11 SURFACE WATER

11.1 SURFACE WATER MANAGEMENT

Figure 11.1 Case 1: Estimated run-off volumes for five-minute duration events

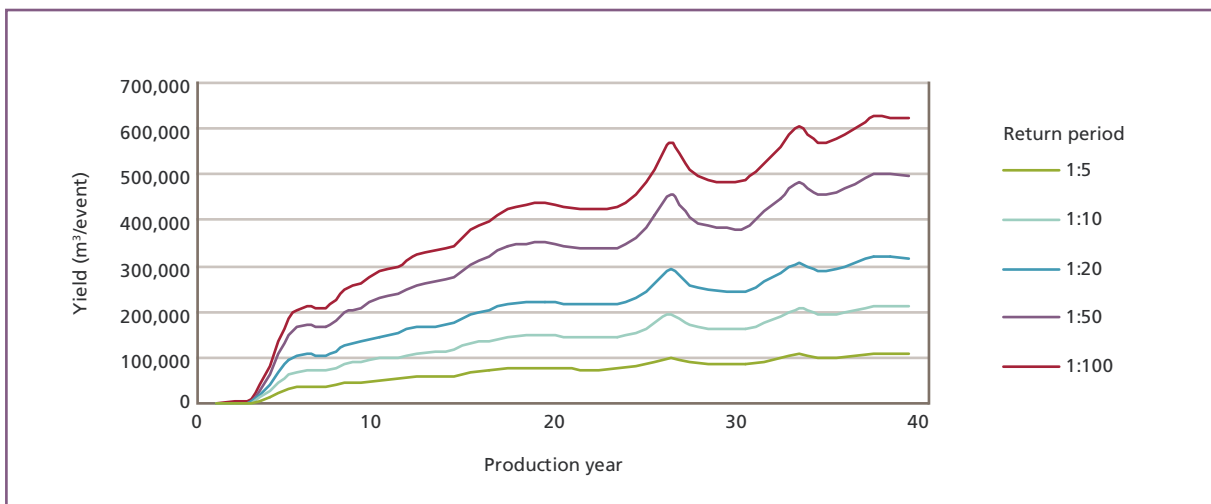
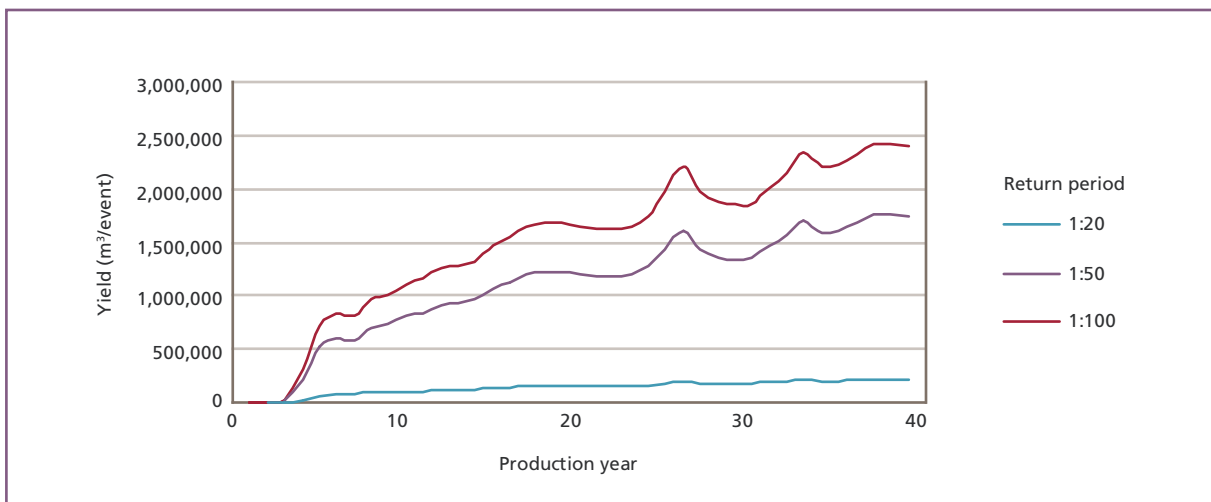
Further information was requested to characterise the water quality and management of potential run-off from the rock storage facility (RSF) and low-grade ore stockpile (LGS), during operation and closure. This information was requested to aid the interpretation of potential impacts on ecosystems in the surrounding swales and to assess the effectiveness of proposed management measures.

As shown in Figures 11.1 and 11.2, while the very short-duration events may generate run-off for the shorter return periods, the total volume of water that would be generated is very small. For example, the run-off generated by a 1-in-100-year storm event lasting five minutes would be less than 700,000 m³ at the end of the RSF life, when its footprint area would be at a maximum. The total rainfall that would occur during such an event (1-in-100-year – 0.083-hour storm) is only about 17 mm, for which only a part of the RSF would yield run-off. It should be noted that a rainfall intensity of 204 mm/h was stated in Table 8.2 of the Draft EIS, however the total rainfall of 17 mm for the same event is the rainfall intensity (204 mm/h) multiplied by the duration of the event (0.083 h). Therefore, very little run-off would actually be expected to occur due to surface undulations, local ponding and attenuation. Note that in the Draft EIS the run-off was estimated using a fixed run-off coefficient of 0.75 for all materials to be placed in the RSF; as indicated by the modelling, the actual run-off is predicted to vary by material and rainfall intensity and duration. The Draft EIS therefore overestimates the modelled run-off that would be expected to occur.

The longer-duration events would generate flows only at the longer return periods of 1 in 20 years and above. As noted above, not all of the run-off that could be generated would be expected to flow to the surrounding natural terrain since flows would be ponded on the surface of the facility due to surface imperfections and depressions and would then evaporate or infiltrate (see below for further details). Disregarding flow attenuation on the surface of the facility (i.e. water ponding in shallow depressions on the surface of the RSF and being prevented from flowing off the surface), the maximum estimated volume of run-off that would need to be contained would occur when the RSF was at its full extent and the volume would be about 2.5 million m³. As noted in Chapter 11 of the Draft EIS, the 1-in-100-year event run-off could be readily contained within the sub-catchments of the expanded SML.

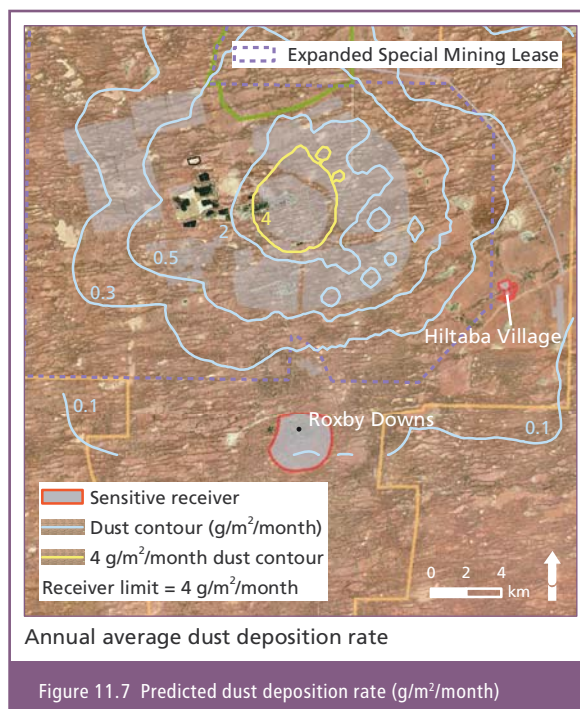
Further information was sought on the potential for acidic run-off to occur from the rock storage facility (RSF) and the impact of stormwater run-off and dust leachability on ecosystems in the natural swales or clay pans in and around the expanded Special Mining Lease.

The predicted extent of the area at or above the maximum deposition limit of 4 g/m²/month was shown in Figure 13.18d of the Draft EIS (updated and reproduced here as Figure 11.7). This indicates that this area would include only the open pit mine, part of the RSF and part of the mineral processing area. The area is not predicted to impact Arid Recovery or significant areas beyond the proposed disturbance footprints.
